SUBJECT: Supplemental application for amend to License NPF-21,
 changing Tech Spec Section 3.7.1.3 (UHS) to permit reliance
 on single spray pond for DHR when plant in mode "star".

June 5, 1986
G02-86-537

Subject: NUCLEAR PLANT NO. 2
OPERATING LICENSE NPF-21, REQUEST FOR AMENDMENT
TO LICENSE - (ULTIMATE HEAT SINK), SUPPLEMENTAL
INFORMATION

SIPHON GEOMETRY

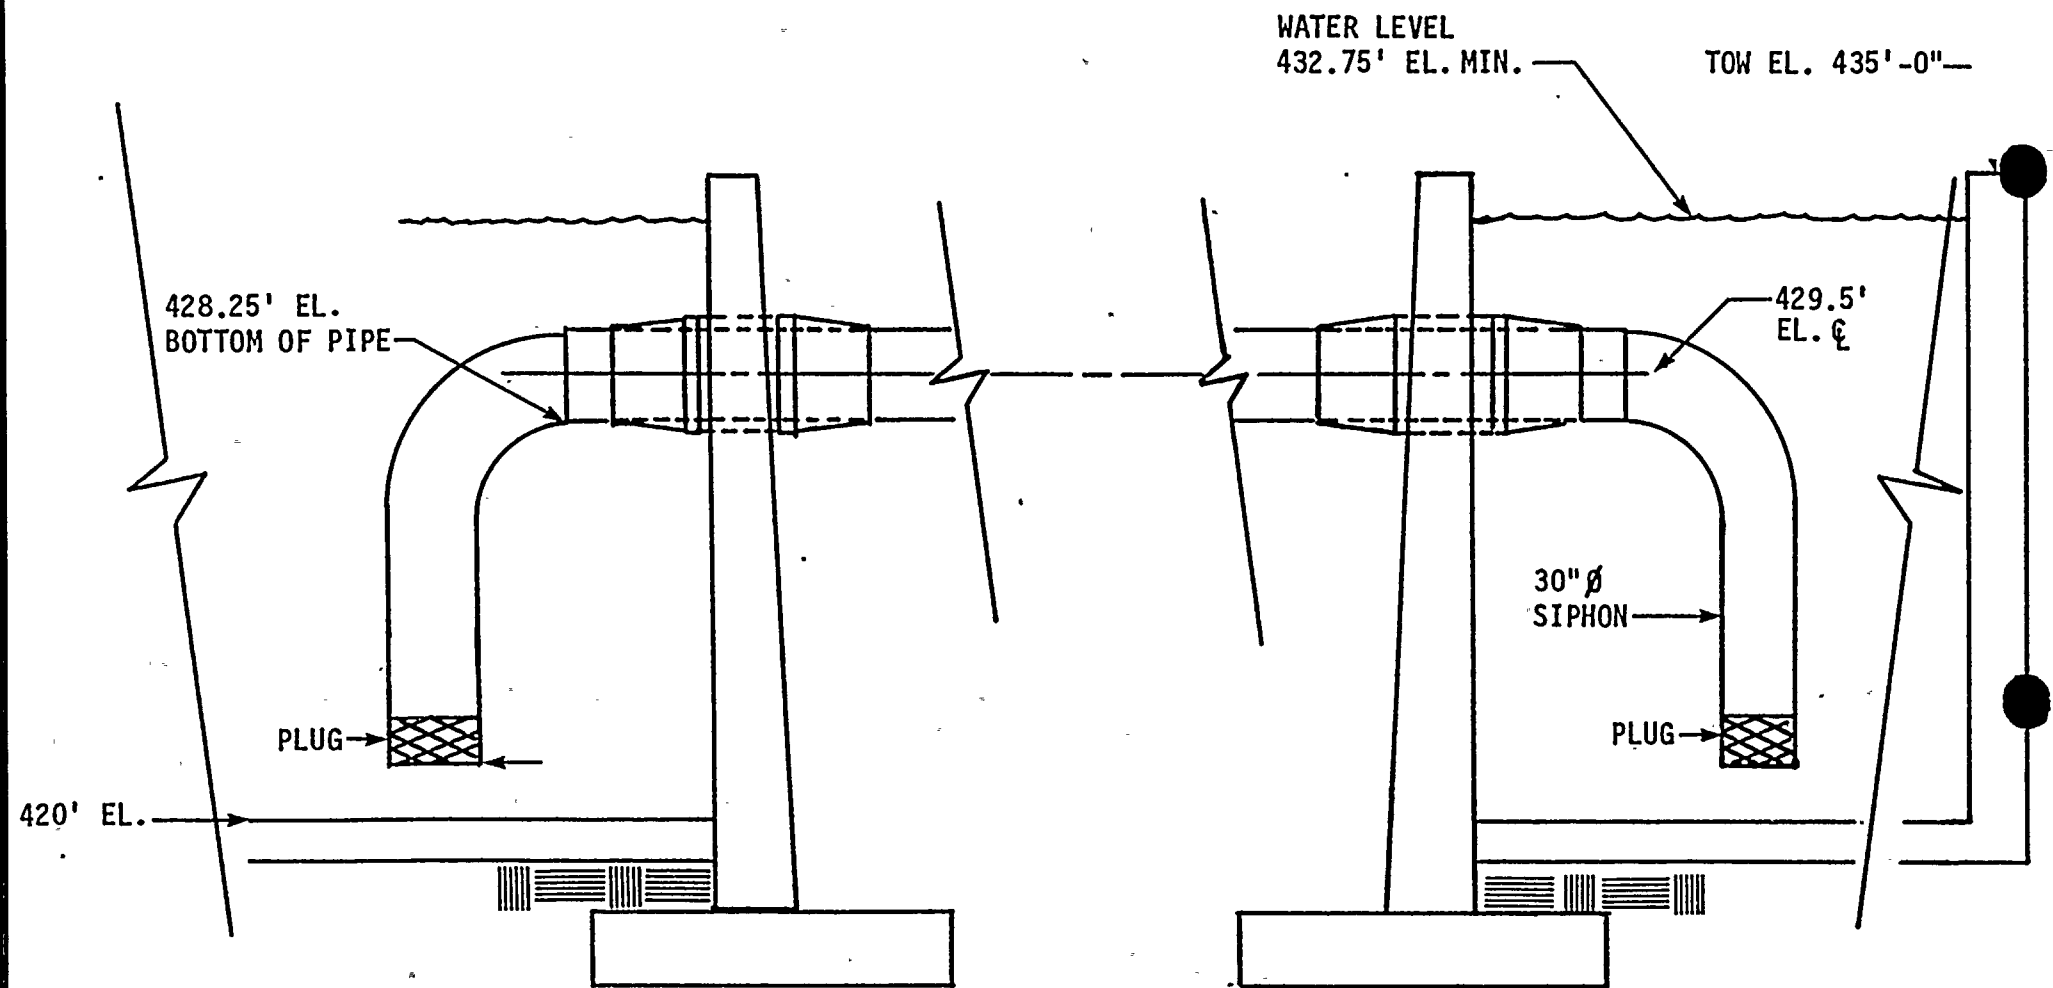
In this phone conversation, additional information was requested on the safety impact of a postulated loss of both inflatable plugs in the siphon of the standby service water cross-connection. During startup testing it was shown that the siphon would not continue to function when the water level in the pond with the most water was below the level of the inter-connecting pipe between the ponds and the water level on the other side dropped below the end of the 30 inch siphon pipe, which is 18 inches above the pond bottom. With the siphon plugged and only one pond full of water, failure of the plugs would allow water to flow to the other pond until the levels equalized. Under this condition, the siphon is self priming because the normal water level in the full pond

is at least 3 feet above the centerline of the 30 inch siphon where it crosses between the ponds (see attached figure). The siphon is then functional, and the water in both ponds is available for use by the operating SW pump except for 1.5' of water in the previously dry pond that the siphon can not access. This water could be transferred with portable pumps or the other division of SW could be put into operation. The loss of direct access to this 1.5' of water still leaves over 19 days to effect the transfer since the balance of the water inventory will last that long. After the 19 days further flow of water through the siphon is not possible and water inventory would be transferred with portable pumps or operation of the other SW division.

The flow of water to the previously empty pond is, therefore, not a loss of water, and constitutes usable volume if the Standby Service Water (SW) pump associated with that pond is brought into service, or other temporary means are used to transfer water from one pond to the other. Ample time is available to make provisions to transfer water back to the original pond, or to bring the other division of SW into operation. The Supply System has analyzed this change according to the criteria of 10CFR50.92 and determined that the subject request can not create the possibility of a new or different kind of accident, as sufficient time is available to marshal the resources necessary to meet the design 30 day inventory requirement.
